The Defense Nuclear Facilities Safety Board (Board) has been following closely the development of safety basis controls and startup activities for the new aqueous recovery line for plutonium-238 (Pu-238) scrap at Los Alamos National Laboratory (LANL).

Staff Issue Report

SUBJECT: Aqueous Processing of Scrap Plutonium-238 Oxide at Los Alamos National Laboratory

Figure 2. Dissolution Filtrate Storage Vessel (Los Alamos National Laboratory, 2002b)

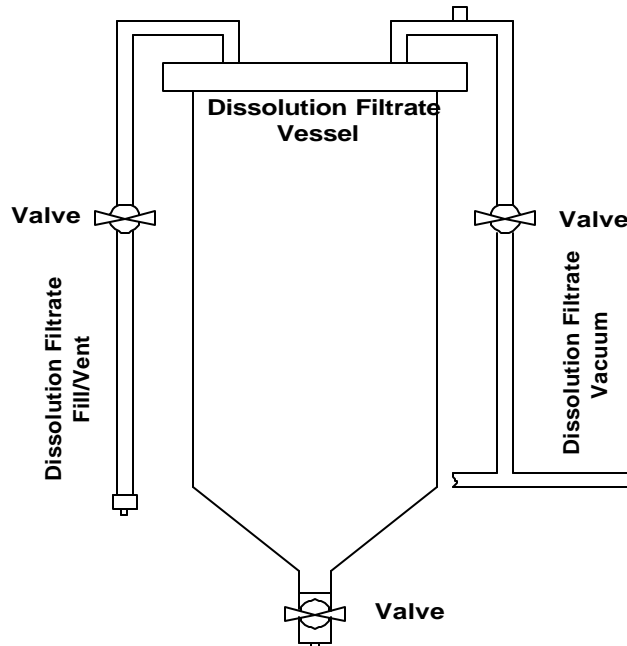
In addition, solutions transferred from the dissolver to the filtrate storage vessels will continue to generate hydrogen at the same rate. The LFL will be reached in the filtrate storage vessels within 6 hours, assuming an unvented 7 liter headspace. The stoichiometric concentration for hydrogen and oxygen will be reached in the storage vessel in less than 2.5 days.

Filtrate Storage Vessel Safety Controls—Neither the PrHA nor the SER analyzes a deflagration in a filtrate storage vessel or identifies functionally classified safety controls to prevent such an event. In response to comments from NNSA on hydrogen generation, LANL states that small amounts of hydrogen will be generated in the storage vessel (Los Alamos National Laboratory, 2003d); as stated above, the staff's analysis shows that the LFL could be reached in less than 6 hours. There are two vessels, and each has a level sensor and pressure relief valve. The pressure relief valve is not functionally classified as a safety control and should not be relied upon to preserve the vessel's integrity in the event of a hydrogen deflagration. The storage vessels do have vent lines, but there are no safety controls identified to ensure that the vent lines are open. Also, the U-shaped configuration of the vent lines will hinder the buoyant migration of hydrogen (see Figure 2). Diffusion of hydrogen will occur through the line, but no analysis has been performed to show that the equilibrium hydrogen concentration in the vessel will remain below the LFL. Since filtrate may be stored for extended periods of time, the possibility exists for flammable amounts of hydrogen to accumulate in the filtrate storage vessel. The opportunity for an ignition source in the filtrate storage vessel is less than that in the dissolver vessel, but a conservative hazard analysis should always assume the presence of an ignition source. A safety control to either vent or purge the vessel would address this accident scenario.

Figure 3. Resin Color as a Function of Alpha Dose (Marsh, 1991)

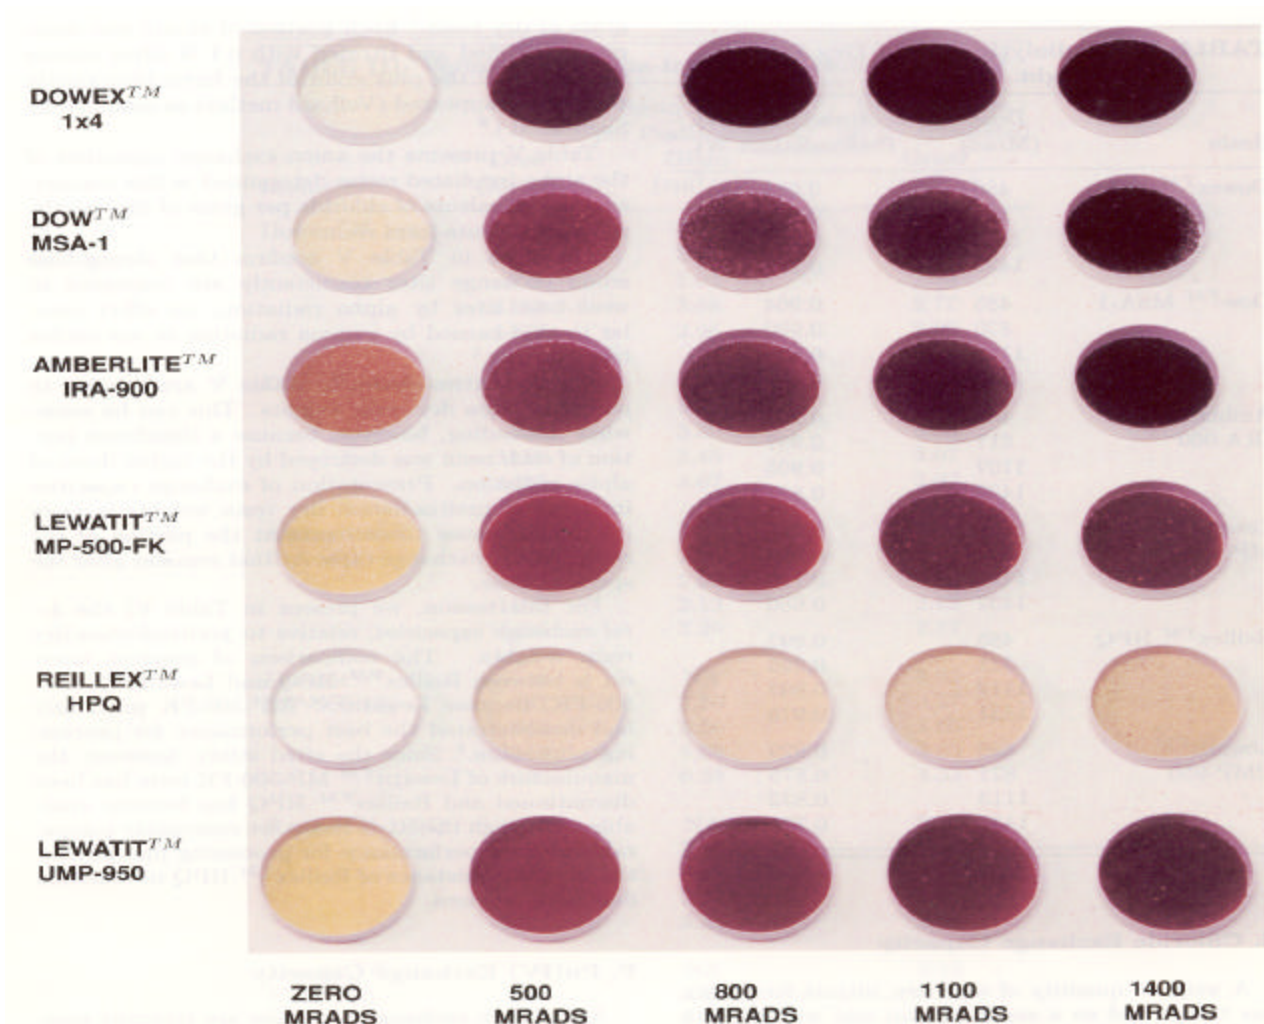
The revised PrHA proposes surveillance of resin exposure in addition to annual resin replacement, but the PrHA and the SER do not explain how this surveillance will be performed. Furthermore, the December 2000 SER imposed what was intended to be a safety factor of two for the resin lifetime. The newly proposed controls accept a reduced safety factor. This reduction in the safety factor, combined with a potentially nonconservative estimation of resin dose, could result in an unsafe resin condition.

Figure 4. Maximum Resin Temperature for Loss of Flow, Maximum Concentration, and Double Loading (Laurinat, J. E. and M. E. Pansoy-Hjevnik, 1999)

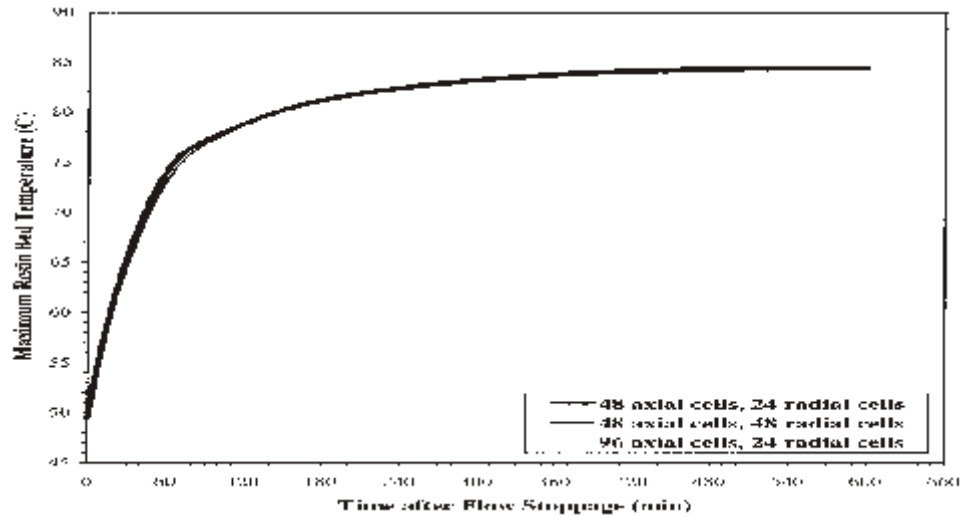
Thermal Analysis—The May 2003 PrHA states that the resin temperature can reach a maximum of 50/C. A thermal analysis was performed by Westinghouse Savannah River Company to determine the maximum temperatures of the ion exchange column (Laurinat and Panson-Hjevnik, 1999). The analysis demonstrated that the column temperature would remain below 50/C under normal operating conditions. However, the calculation concluded that the column could reach approximately 84/C under abnormal conditions (see Table 1 and Figure 4). This scenario assumes that the resin has been loaded with twice the normal quantity of Pu-238 and that there is no flow of solution through the column. High column temperatures would degrade the resin, leading to further heat evolution. The column could eventually dry out or pressurize from evaporated water. Moreover, if the column heated to such a temperature, self-heating of the resin could initiate, as shown by the bomb calorimeter testing discussed below.

The staff believes the abnormal conditions that could lead to self-heating of the resin are credible. The pumps that provide solution flow through the columns are not functionally classified, and their reliability was not considered in the hazard analysis. Furthermore, although loading two batches of Pu-238 on the resin columns is not allowed in the operating procedure (Los Alamos National Laboratory, 2002d), the resin is physically capable of holding significantly more than a double batch of Pu-238. Kyser (2000) has demonstrated that the 2 liter volume of the Reillex HPQ resin to be used in the column can adsorb 234 g of Pu. LANL has provided the Board's staff with documentation indicating that the maximum weight percent of Pu-238 in the scrap Pu feed material is 85 percent. Therefore, a column could be loaded with up to 198.9 grams of Pu-238, whereas the double-batch scenario in the thermal analysis considered only 150 grams of Pu-238. The maximum temperature of a fully loaded column has not been analyzed, but would likely be substantially greater than 84/C if there were no flow of solution through the column.

Figure 5. Rate of Thermal Increase as a Function of Resin Temperature (Crooks, W. J., 2001)

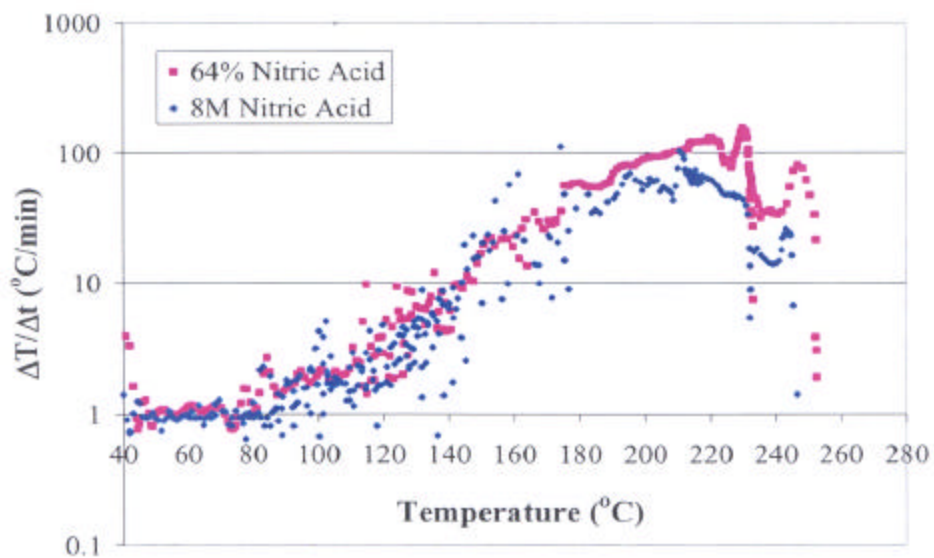
The PrHA indicates that the resin remains safe for temperatures below 120/C. However, Crooks (2001) has shown that the Reillex HPQ resin may initiate self-heating at temperatures as low as 81/C in a calorimeter. The bomb calorimeter was used to allow external heating of the resin at a rate of 1/C per minute to determine resin stability as a function of temperature. The external heating may also simulate the increase in temperature due to radioactive decay upon loss of flow. Figures 5 and 6 show that self-heating begins at approximately 81/C, and temperatures proceed to climb quickly. Resins tested in 8 M and 12 M nitric acid reached a maximum temperature of approximately 250/C in 1 to 2 hours.

Figure 7. HAN/HNO₃ Instability as a Function of Temperature (U.S. Department of Energy, 1998)

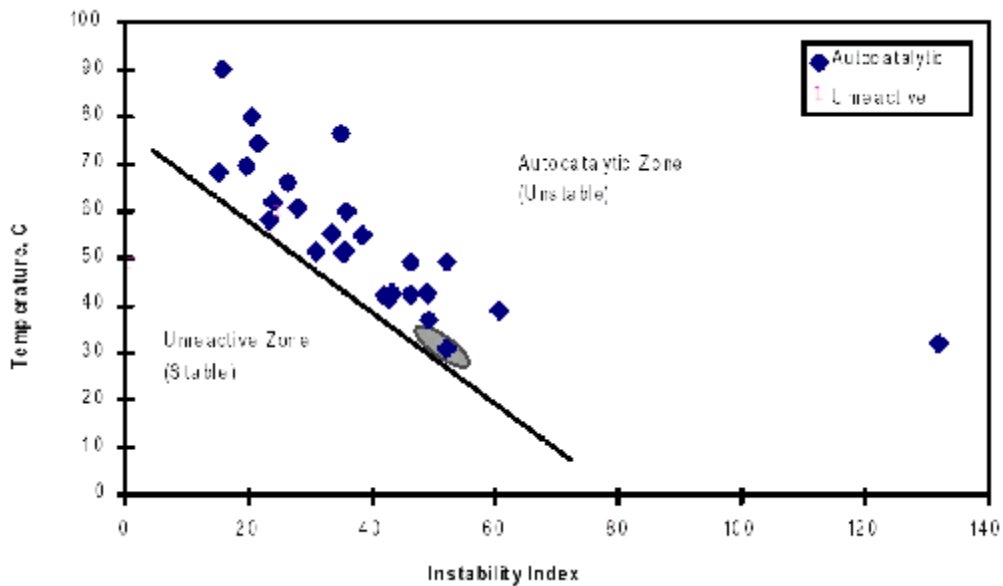
The HAN used in the recovery line is 2.8 M. DOE's technical report suggests that HAN concentrations below 2–3 M lack the necessary energy density to generate high pressures or explosive

reactions. Therefore, the 2.8 M HAN solution used by LANL appears to be in an intermediate range with respect to energy density. At a HAN concentration of 2.8 M, the heat of reaction may vaporize enough water to concentrate the HAN and thus increase its energy density to an unsafe regime.

The March 2000 PrHA did address reactivity hazards of HAN, but identified no functionally classified controls. The Board's April 2002 letter stated that LANL had yet to demonstrate how the recommendations provided in DOE's technical report on HAN had been implemented in the recovery line, as required by NNSA's December 2000 SER. The January 2003 and May 2003 PrHAs reanalyze the consequences of a HAN/nitric acid reaction and propose dual independent administrative verifications of acid concentration to prevent undesirable reactions. This control is not captured as a TSR. Given the numerous other administrative controls, it is not clear to the Board's staff that the verification of acid concentration will be implemented with a rigor commensurate with its importance to worker safety. The report of a LANL readiness review of the aqueous recovery line performed in July 2002 concluded that overuse of second-person verifications limits their effectiveness (Los Alamos National Laboratory, 2002e). The staff believes verification of acid molarity would be implemented with greater certainty if specified as a TSR.
